Department of Energy

RESPONSE TO THE U.S. NUCLEAR REGULATORY COMMISSION (NRC) AUDIT
OBSERVER INQUIRIES (AOI) FROM THE BECHTEL SAIC COMPANY, LLC (BSC),
QUALITY ASSURANCE AUDIT BQAP-BSC-05-07

Reference: Ltr, Collins to Williams, dtd 1/9/06 (NRC Observation Audit Report
No. OAR-05-05, Observation Audit of Bechtel SAIC Company, LLC, Internal
Audit BQAP-BSC-05-07)

**RESPONSE TO NRC AUDIT OBSERVER INQUIRIES
AOI-OAR-05-05-01 THROUGH AOI-OAR-05-05-05,
AREAS OF WEAKNESS, AND OTHER ISSUES ASSOCIATED WITH
NRC OBSERVATION AUDIT REPORT**

Figure 1. THC Simulations: Modeled Total Aqueous Chloride Concentrations as a Function of Time for Various Model Locations; Homogeneous and Heterogeneous Fracture Permeability Fields (1x and 10x Mean Infiltration Rates)

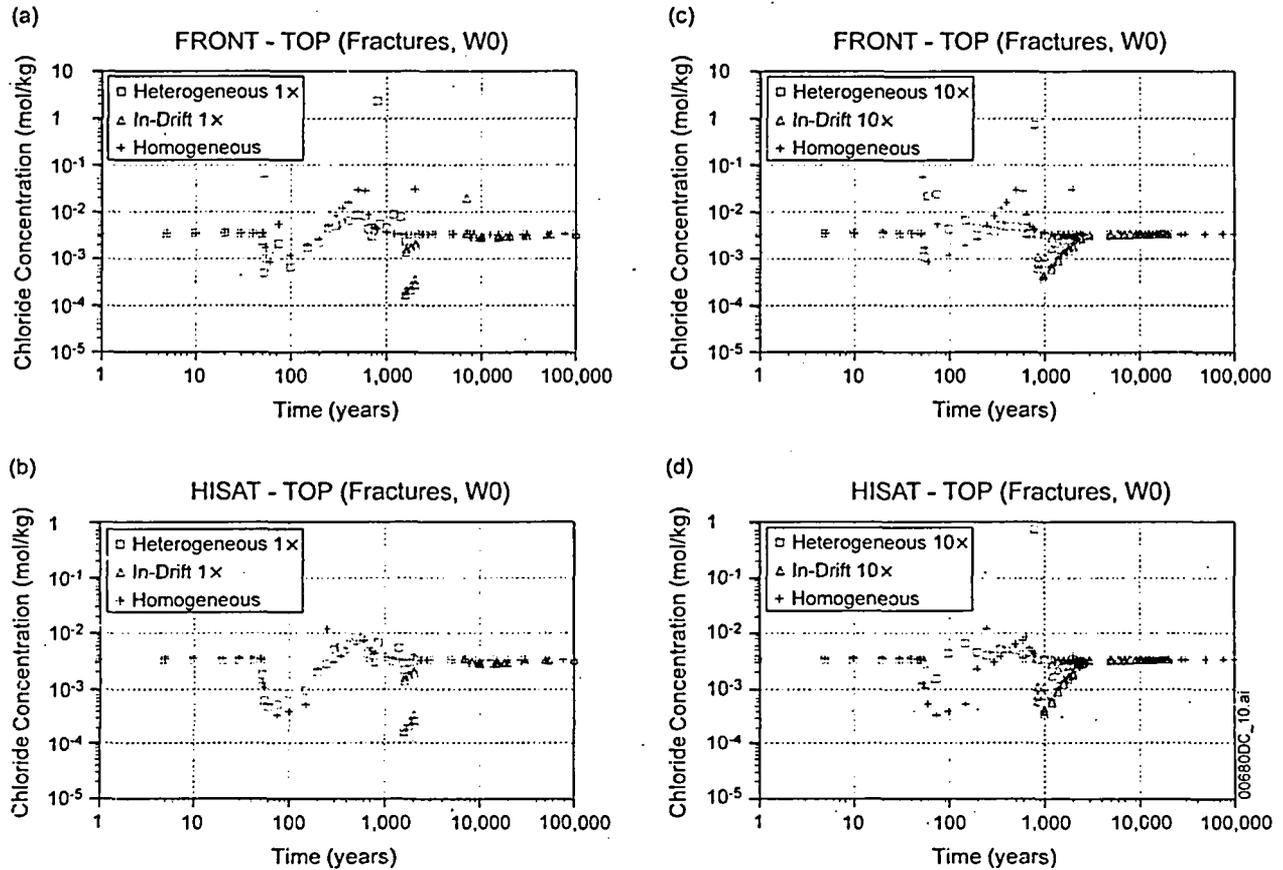
The report also used the Drift Scale Test results (Figure 6.2-2) to support the above argument. However, Figure 6.2-2 was obtained during the heating phase of the test; there might not be enough time for the salt to accumulate in the heated zone.

(2) Dilute Composition of Seepage in THC Modeling—The second approach to evaluating the potential for seepage at temperatures of 100°C or greater is to directly analyze the predicted composition of seepage for conditions when seepage does occur. This approach involves integrating aspects of the two ambient seepage models (i.e., the seepage calibration model and the seepage model for performance assessment) (BSC 2004d; BSC 2004b) with the THC seepage model (BSC 2005c). A sensitivity analysis (BSC 2006, Sections 6.2 and 6.3) was conducted combining the hydrologic parameters used in the ambient seepage models with the THC seepage model elements (BSC 2005c, Section 6.5). The combination of these models is referred to in this response as the integrated THC seepage model.

The integrated THC seepage model simulations (BSC 2006, Section 6.2) were done with a realization of the heterogeneous fracture permeability field using the statistics from the seepage model for performance assessment (BSC 2004b), and percolation flux of 6, 16, and 25 mm/yr corresponding to the present-day, monsoonal, and glacial-transition climate states, respectively. Simulations were also done in which these boundary fluxes were increased 10-fold. Water compositions from the model grid within the host rock were analyzed for pre-defined time steps (BSC 2006, Sections 6.2 and 6.3). In addition, when seepage was produced in the heterogeneous simulations, the composition of that seepage was evaluated directly. All heterogeneous simulations were based on the W0² pore water composition (BSC 2005c, Section 6.2.2.1) as the initial condition and compositional boundary condition for the fractures and rock matrix. The W0 composition is one of five initial pore water compositions used by the THC seepage model. The

Study results show that the predicted seepage waters are comparable to, or more dilute than, compositions retrieved from within the host rock for the heterogeneous and homogeneous permeability simulations. In addition, the predicted seepage waters are very dilute compared to the brine strength required for waters to exist at 100°C and relative humidity of 87.9% (BSC 2006, Section 6.2 and Figures 6.2-23 to 6.2-26, 6.2-29, and 6.2.30). Figure 1 provides example results of chloride concentration histories. More detailed information on predicted seepage compositions and temperatures for the 1× and 10× percolation flux cases is given in Tables 1 and 2. In all cases, seepage occurred only when drift-wall temperature was less than 100°C. Thus, within the temporal resolution of reported model results, the compositions corroborate discussions presented previously that seepage of concentrated brine, at temperatures of 100°C or greater, is unlikely.

Figure 2. THC Seepage Model (Tptpl1): Vertical Profile of Predicted Mineral Abundances above the Drift Crown at 600 and 2,400 Years Using Input Water Composition W0 and Fixed Infiltration Rates (6 and 25 mm/yr)

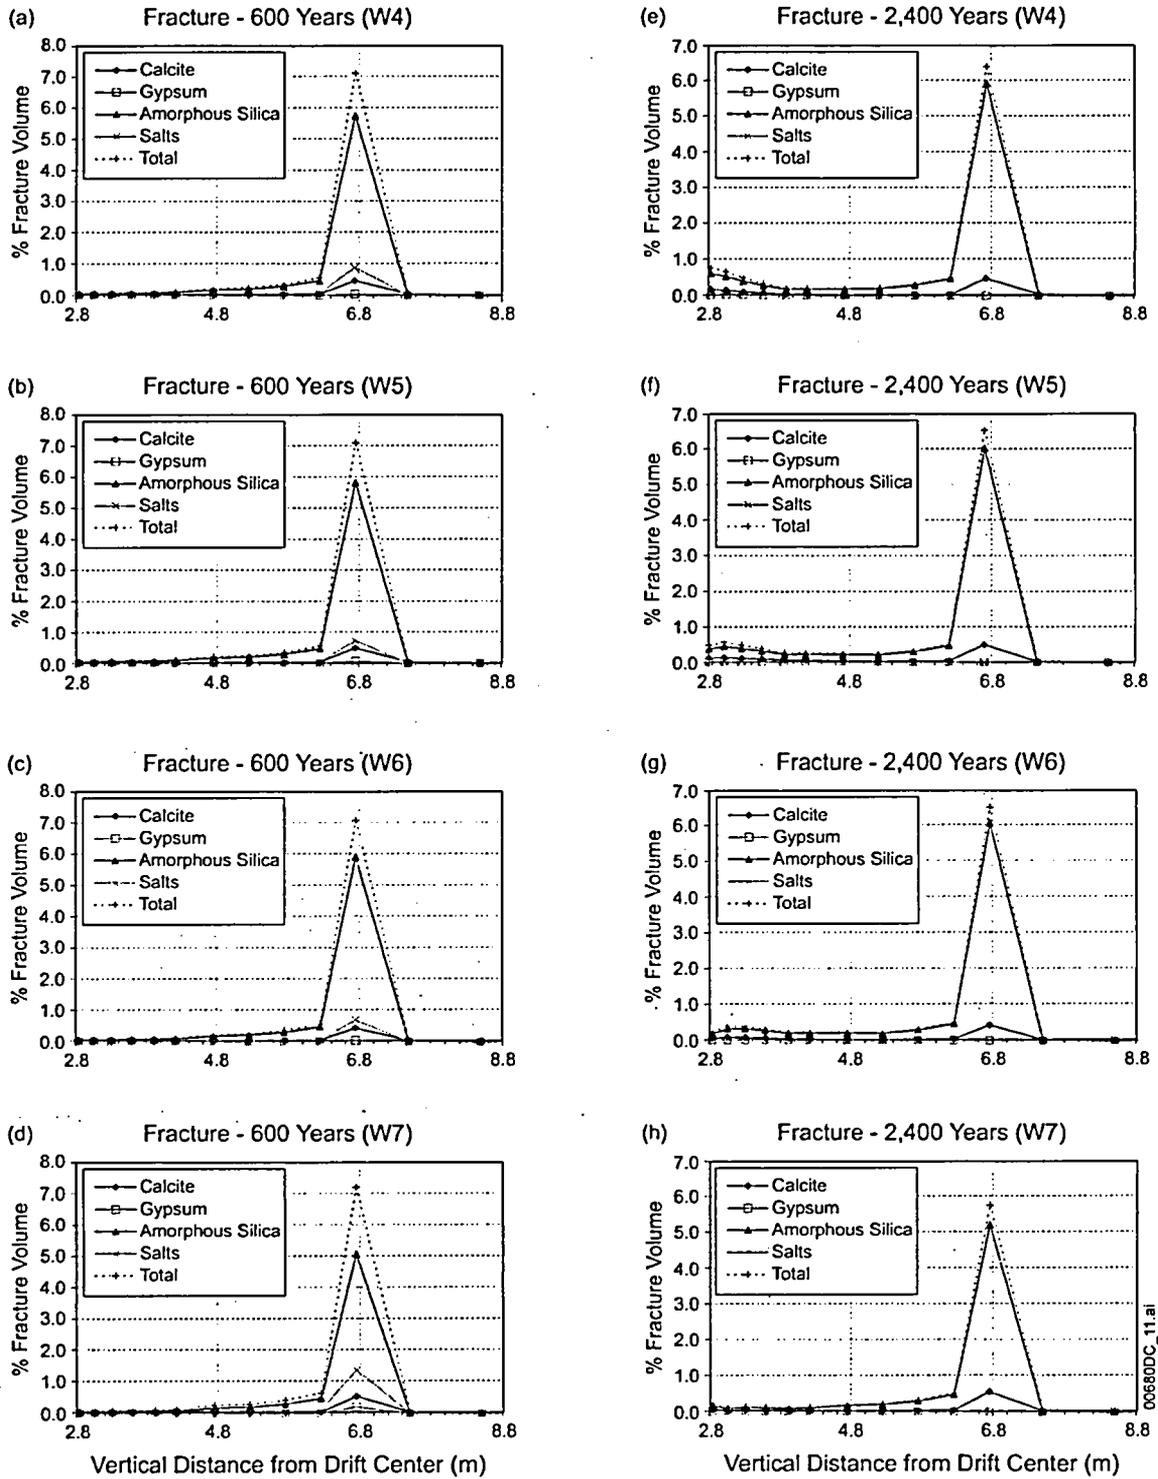
(3) Limited Salt Accumulation and Potential Brine Volume—The third point supporting the use of the 100°C threshold is the limited salt accumulation and associated potential brine volume. Simulations using the validated THC seepage model (BSC 2005c, Section 6.5) show that soluble salts accumulate mostly where the boiling front persists for the longest time. Evaporation of incident percolation flux and condensate reflux in this zone builds up minerals and soluble salts in the fractures. Mass transfer between the fractures and matrix is limited, so that the precipitated salts form predominantly in the fractures.

Modeling results (Figures 2 and 3) show that, over the approximately 1,500-year period of salt accumulation, amorphous silica is the major contributor to fracture mineralization, and that the accumulation of very soluble salts (typically halite) is on the order of 1% of fracture volume. This prediction is reasonable considering the total amount and the composition of formation water that is evaporated during the thermal period. It is not particularly sensitive to the compositional boundary and initial conditions (Figures 2 and 3) or to the implementation of dryout and redissolution of soluble salts in the THC seepage model.

Figure 1. Comparison of Scanning Electron Microscopy–Imaged Alloy 22 Coupons Exposed at 30°C (a) Untested (8,000×), (b) Sterile Incubated at 30°C for 34 Months (8,000×), and (c) Biotically Incubated at 30°C for 43 Months (10,000×)

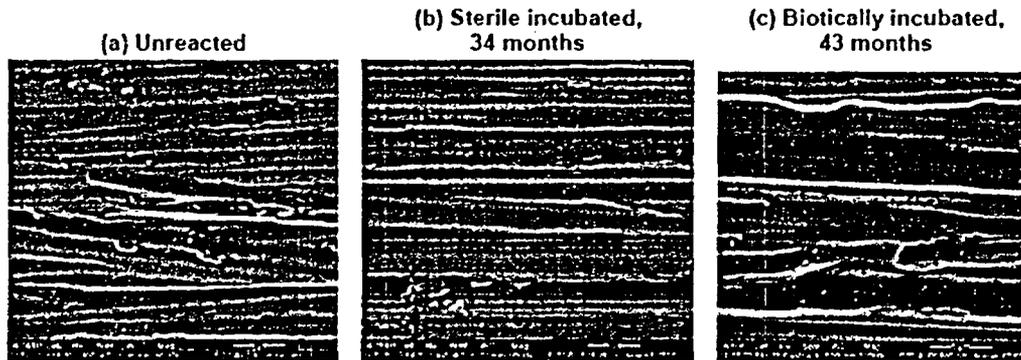
NRC Audit Observer Report Section 4.5.2.2 states:

[T]he NRC observers identified the need for additional justification for modeling microbiologically induced corrosion, using a scaling factor to the generalized corrosion model. The scanning electron micrographs of the corrosion under biotic conditions in Figure 6-67 of ANL-EBS-MD-000003, appear significantly different from typical general corrosion. Specifically, the NRC observer noted that micropores were found on the specimens that were tested under the biotic condition. This may be an indication of localized corrosion, as opposed to general corrosion.

This response provides the basis and justification beyond what is provided in *General Corrosion and Localized Corrosion of Waste Package Outer Barrier* (BSC 2004) for modeling microbially influenced corrosion with a scaling factor for general (not localized) corrosion in light of the fact that scanning electron micrographs (BSC 2004, Figure 6-67, p. 6-106) indicate that the corrosion morphology under biotic conditions appears different from general corrosion.

In the study that produced these scanning electron micrographs (BSC 2004, Figure 6-67, p. 6-106), Alloy 22 (UNS N06022) coupons were incubated with sterile or nonsterilized Yucca Mountain rock in simulated concentrated (10×) groundwater supplemented with 0.1% glucose for almost 5 years (Martin et al. 2004). Coupons were incubated with Yucca Mountain tuff that was either left unsterilized or was pre-sterilized prior to being placed in the experimental vessels held either at room temperature or 30°C. Alloy 22 coupons from microcosms held at 30°C were withdrawn, cleaned, and imaged using scanning electron microscopy. An unreacted Alloy 22 coupon was also cleaned in the same manner and imaged in parallel for comparison. These scanning electron microscopy results are shown in Figure 1. Coupons incubated in the nonsterile microcosm reactors showed the development of micropores, primarily along the ridges formed by polishing, while coupons incubated in sterile microcosms and those that were not reacted in microcosms showed no evidence of pinhole formation after one cleaning cycle (although repeated cleaning cycles resulted in formation of micropores). The micropores appeared uniform in shape except where they had grown together and ranged in size from 0.2 to 0.7 μm in diameter.
